## EMERSON PARK JSP17-10

Public hearing at the request of Pulte Homes, LLC for Planning Commission approval of the Preliminary Site Plan with Wetland Permit, Woodland Permit, and Stormwater Management Plan. The subject property is currently zoned RM-2 (High-Density Multi-Family Residential) with a Planned Rezoning Overlay Agreement associated. The subject property is approximately 24-acre and is located on the west side of Novi Road and north of Ten Mile Road in Section 22. The applicant is proposing a development of 120-unit multi-family attached condominiums with frontage and access to Novi Road.

## PLANNING REVIEW

Preliminary Site Plan

sheet title:  
**OVERALL PLANTING  
PLAN VIEW**

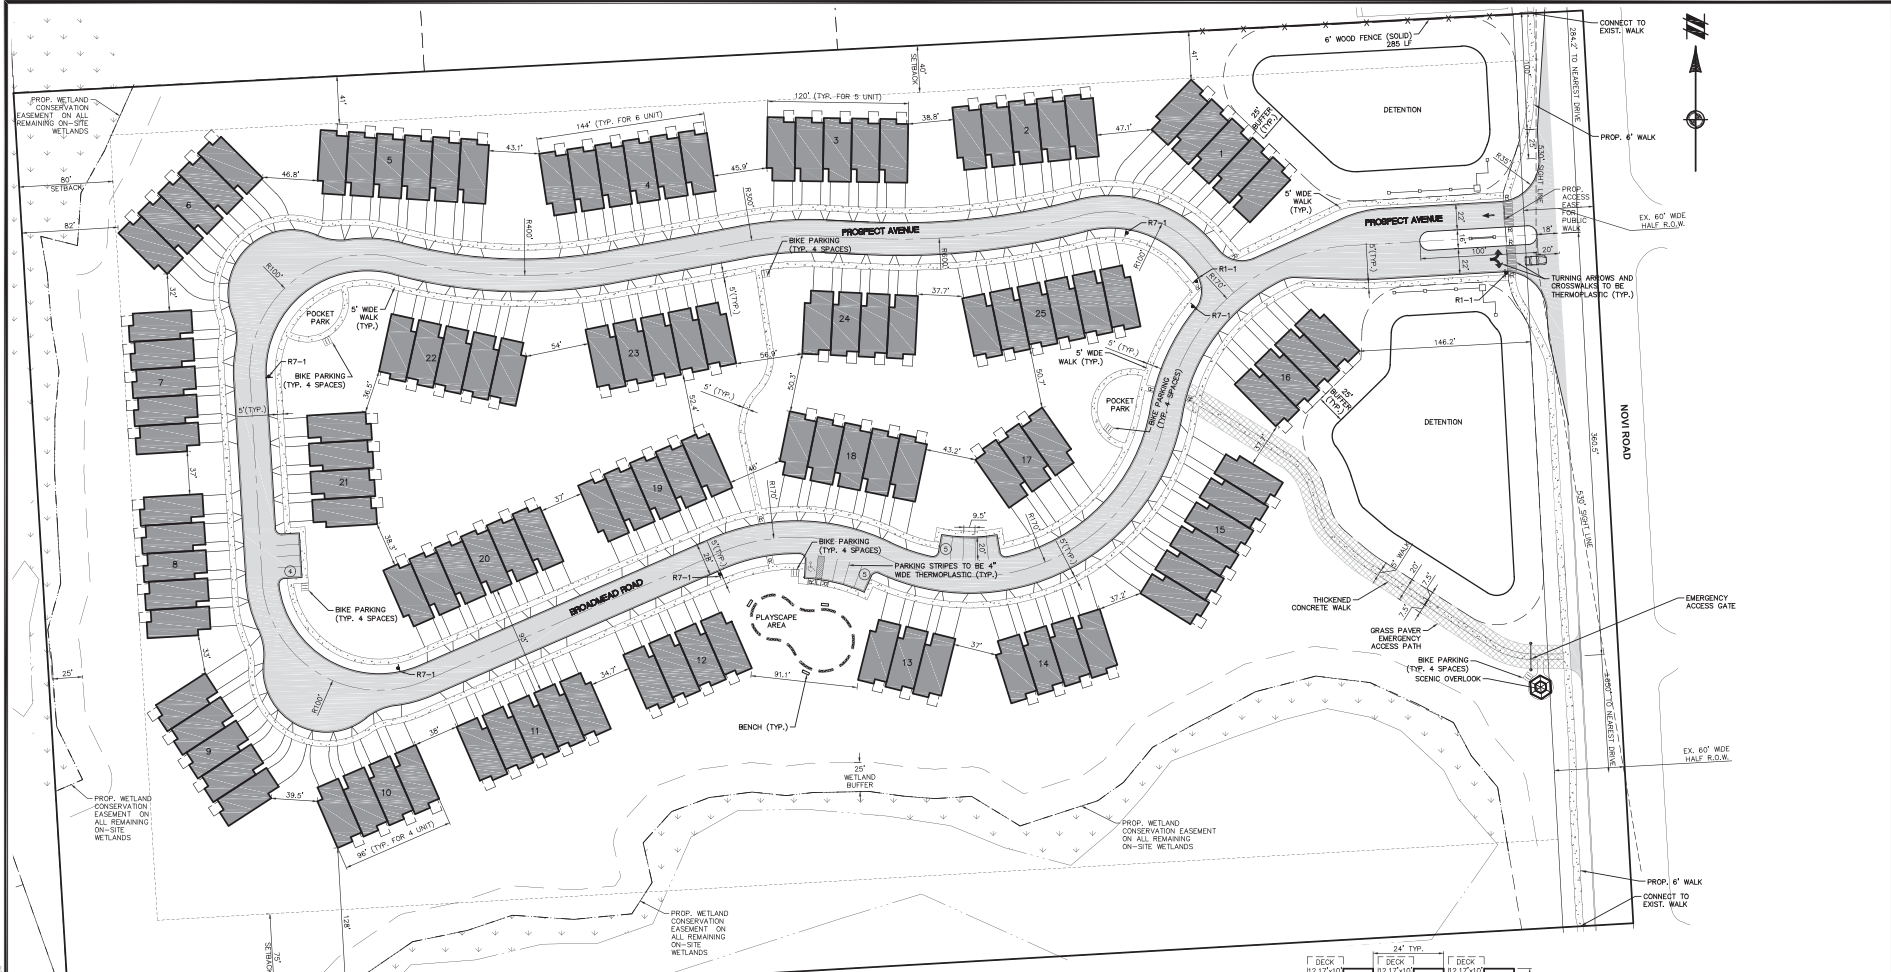
**Please add this list of approved deviations to Sheet LS-1.**

**Figure 1.** City of Novi Regulated Wetland & Woodland Map (approximate project area is highlighted in red). Regulated Woodland areas are shown in green and regulated Wetland areas are shown in blue.

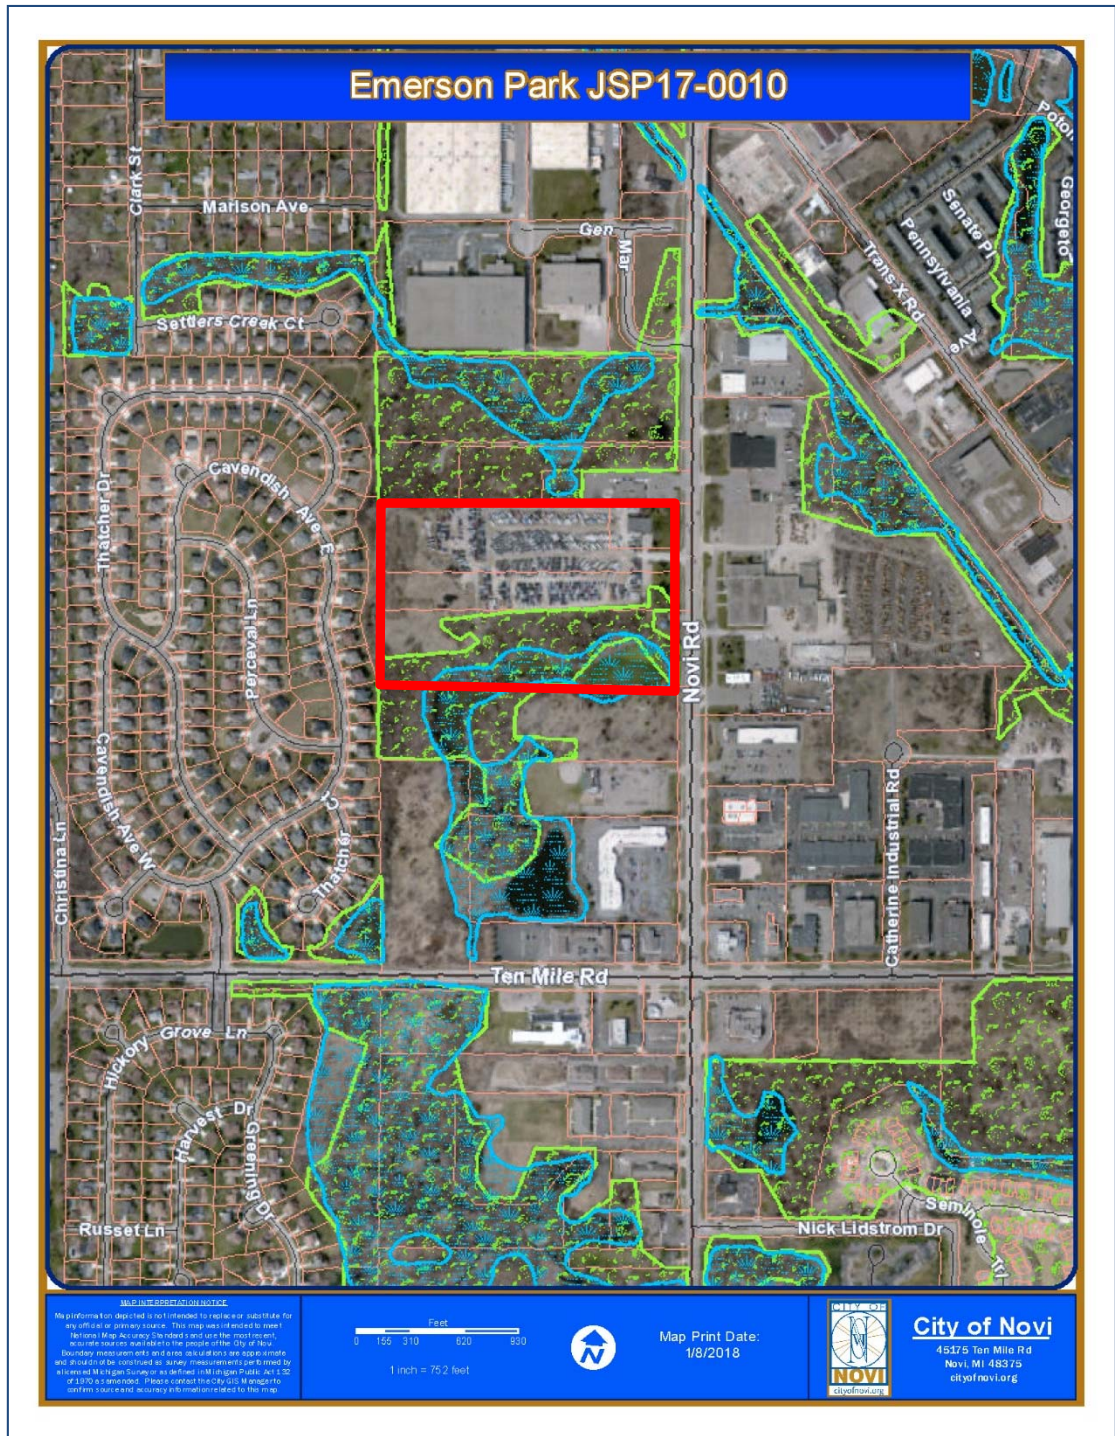
Based on our review of the Plan, Novi aerial photos, Novi GIS, the City of Novi Official Wetlands and Woodlands Maps (see Figure 1, attached) and our initial site visit on February 21, 2017, it appears as if this proposed project site contains City-regulated wetlands and woodlands. The City's Regulated Wetland and Woodland map shows that the overall property contains wetlands along its southern side. However, as confirmed in our on-site evaluation, the site contains three (3) areas of wetland (Wetlands #1, #2, and #3), located along both the southern and western portion of the site.

**Figure 1.** City of Novi Regulated Wetland & Woodland Map (approximate project area is highlighted in red). Regulated Woodland areas are shown in green and regulated Wetland areas are shown in blue.

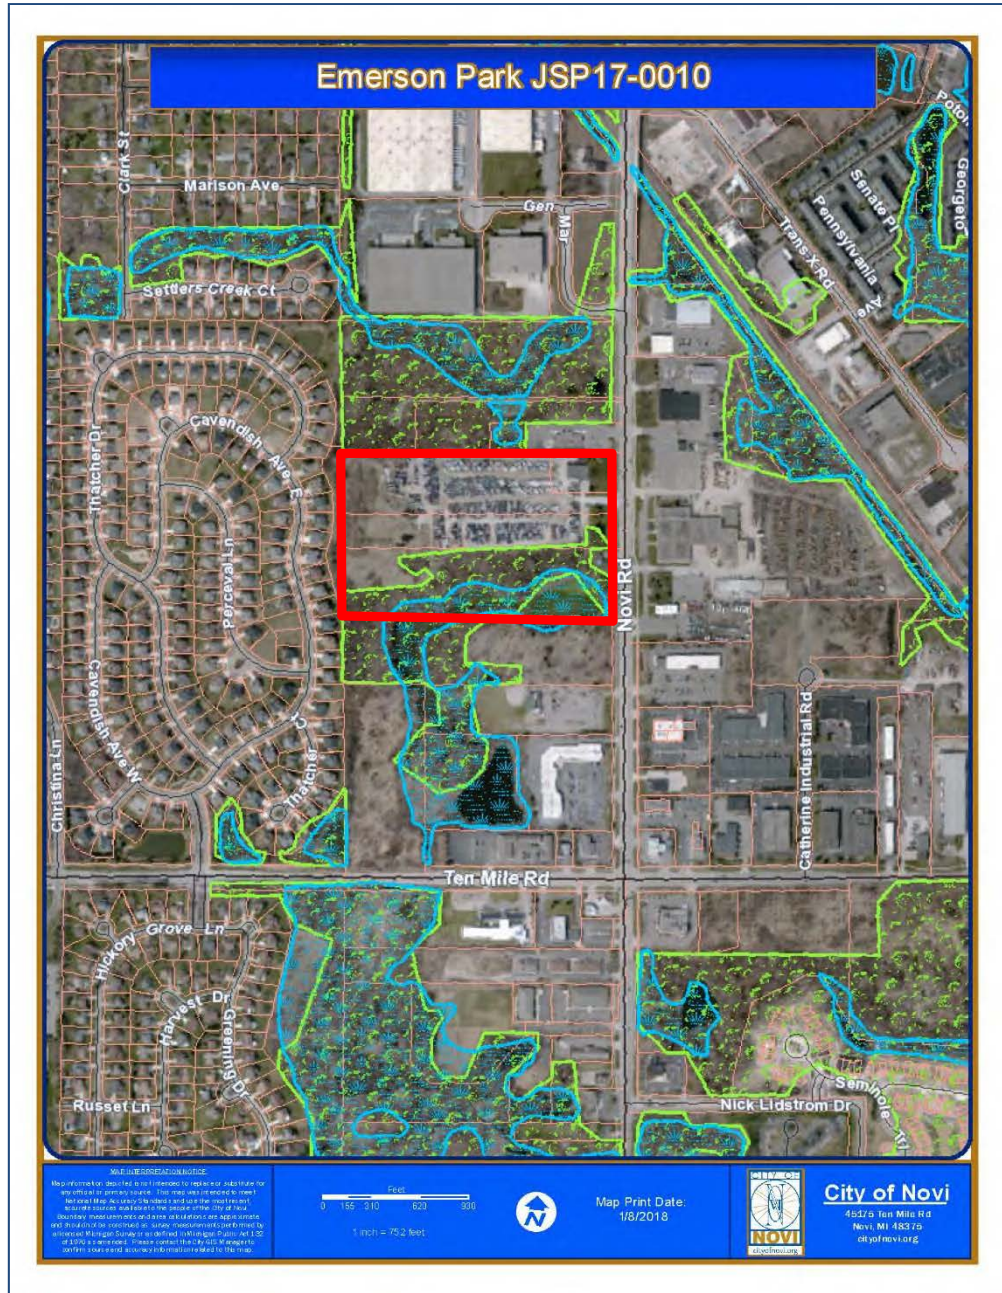
ECT completed an on-site woodland evaluation on Tuesday, February 21, 2017. As noted above, the site does contain area designated as City of Novi Regulated Woodland. A significant portion of the proposed limits of disturbance for the project is located outside of the areas mapped as City Regulated woodland. The majority of the Regulated Woodland area is located on the southern portion of the project site (see Figure 1). Tree survey information has been provided on the *Tree List* plan (Sheet 03). This sheet includes a tree list that indicates the proposed woodland impacts/tree removals and required Woodland Replacement tree credits for these removals. This Sheet (*Woodland Summary* list) indicates that a total of **328** trees have been surveyed for the project. Of the trees surveyed, 262 trees are located within the area designated as Regulated Woodland (i.e., 80% of the surveyed trees are located within the regulated woodland area). Fifty percent (50%) of the surveyed trees are comprised of the following tree species:
